Access Compliance Report

Public Rights-of-Way

Intersection ID: 45173	Main Street: LINDEN_TREE_LN	Cross Street: MAPLEHURST_DR	Location: SW
ADA ID: C613B8A5E8A9	Ramp Type: Perp	Initial Pass/Fail: Fail	Overall Compliance: No
		Severity Score: 25

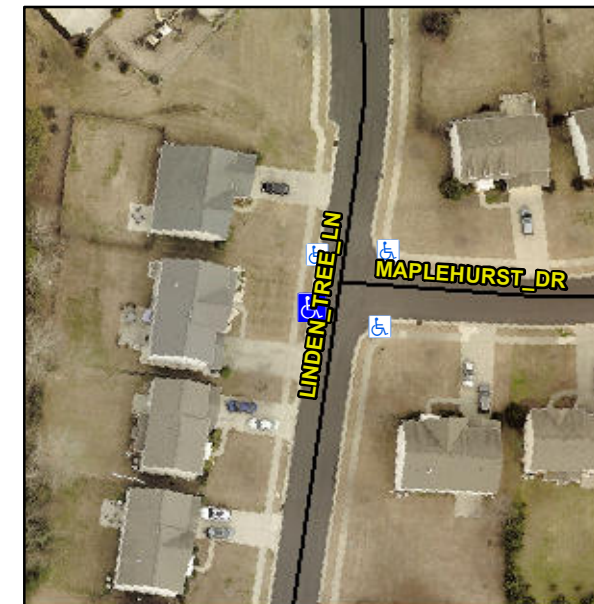
Not Found, R304.2.2

Compliance	Description	Data	Compliance	Description	Data
N/A	Ramp Length (in)	48.0	No	Ramp Slope (%)	13.7
Yes	Ramp Width (in)	48.0	Yes	Ramp XSlope (%)	1.3
N/A	Flare Type LT	N/A	N/A	Flare Type RT	N/A
N/A	Flare Slope LT (%)	N/A	N/A	Flare Slope RT (%)	N/A
N/A	Flare Traversable LT?	N/A	N/A	Flare Traversable RT?	N/A
N/A	Landing Length (in)	N/A	N/A	DWS Provided?	N/A
N/A	Landing Width (in)	N/A	N/A	DWS Contrast?	N/A
N/A	Landing Slope (%)	N/A	N/A	DWS Length (in)	N/A
N/A	Landing X Slope (%)	N/A	N/A	DWS Full Width?	N/A
N/A	Landing Curb? (Y/N)	N/A	N/A	DWS Offset (in)	N/A
N/A	Shared Landing?	N/A			
N/A	Gutter Ponding?	N/A	N/A	Gutter Slope (%)	N/A
N/A	Gutter Lip Ht (in)	N/A	N/A	Gutter X Slope (%)	N/A
N/A	Painted X Walk1?	No	N/A	Painted X Walk2?	N/A
	X Walk 1 Direction	To SE		X Walk 2 Direction	N/A
N/A	X Walk 1 Width (in)	N/A	N/A	X Walk 2 Width (in)	N/A
	X Walk 1 Slope (%)	3.3		X Walk 2 Slope (%)	N/A
	X Walk 1 X Slope (%)	2.0		X Walk 2 X Slope (%)	N/A

Remove & Replace Entire Ramp.
